PacDrive™ Sercos Firmware-Assistent V2.0 -> V2.6

Fig. 1 The actual state of device detection is shown in the "Hardware" area

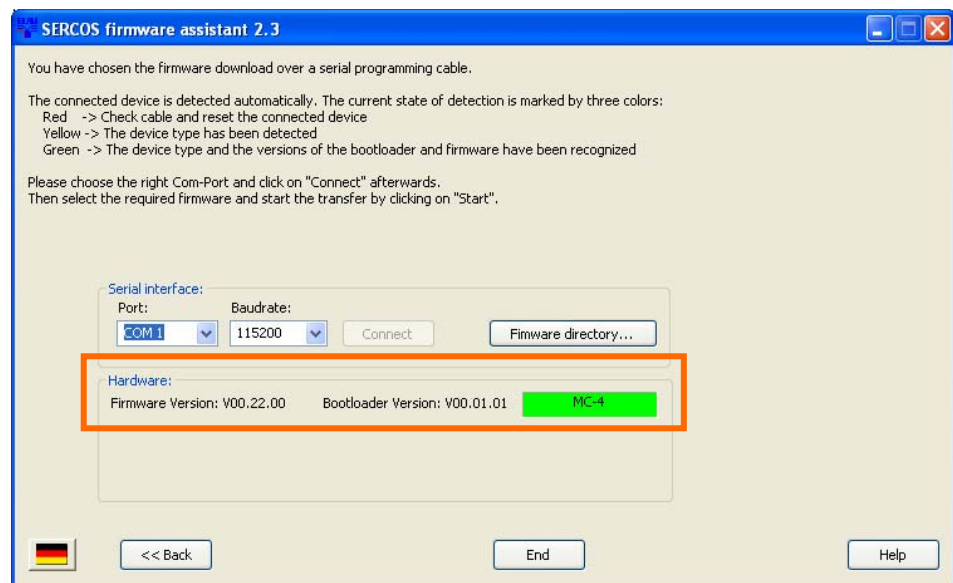
SCR 4702 The "COM" button on the start page leads to the firmware download page via the serial interface as usual. Now automatic device detection is executed. It remains active until either the button "Back" or "Connect" is selected.

During this time, the serial interface cable can be connected to a device and disconnected again. The detection takes place in three color-coded steps. The actual state is shown in the "Hardware" area (see Fig. 1):

Fig. 4 Errors are shown before scanning

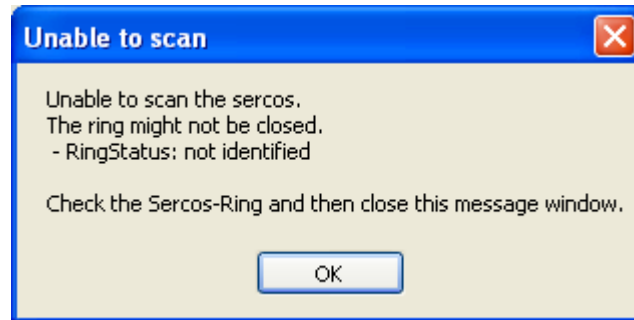
SCR 3799 Before scanning the Sercos bus for devices, the SERCOS ring is checked. Possible errors and information on how to solve them is shown in a message window (see Fig. 4).

Fig 6 In the bottom window SERCOS-Scan the diagnosis messages are displayed in red and extra bold type.

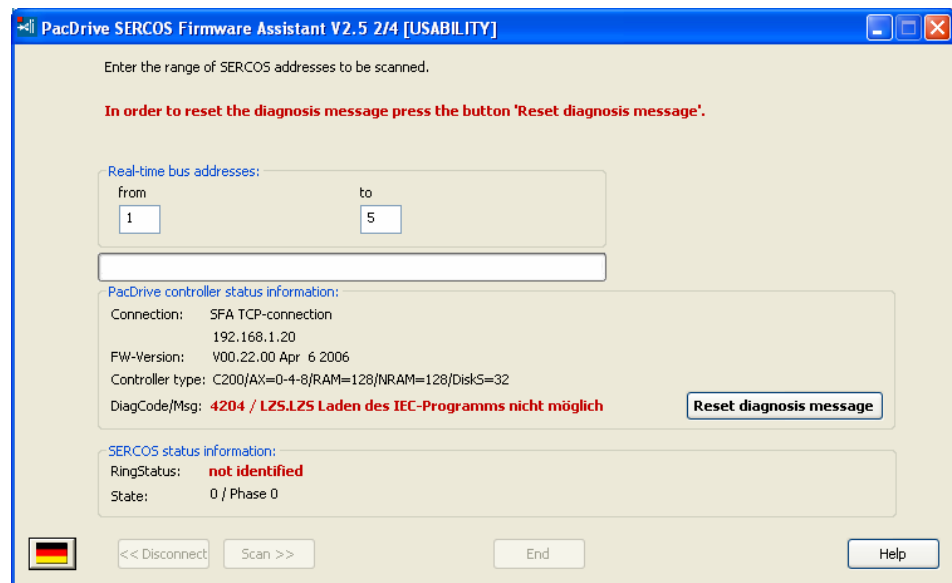
SCR 4998 The operator guidance inside the rear side of the SERCOS-Scan shows the current status of the SERCOS-Ring and the diagnosis message. Errors are displayed in red and extra bold type. In the top area information is given for error deletion.

Fig 7 Before calling the rear side „SERCOS-Scan“, the IEC-Program is stopped and SERCOS is set to phase 0.

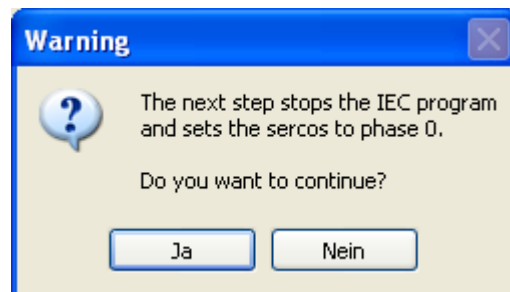
Before calling the rear side of the SERCOS Firmware Assistant, the controller is stopped and SERCOS set to phase 0. The user has to confirm this in the previous step via the information dialog.
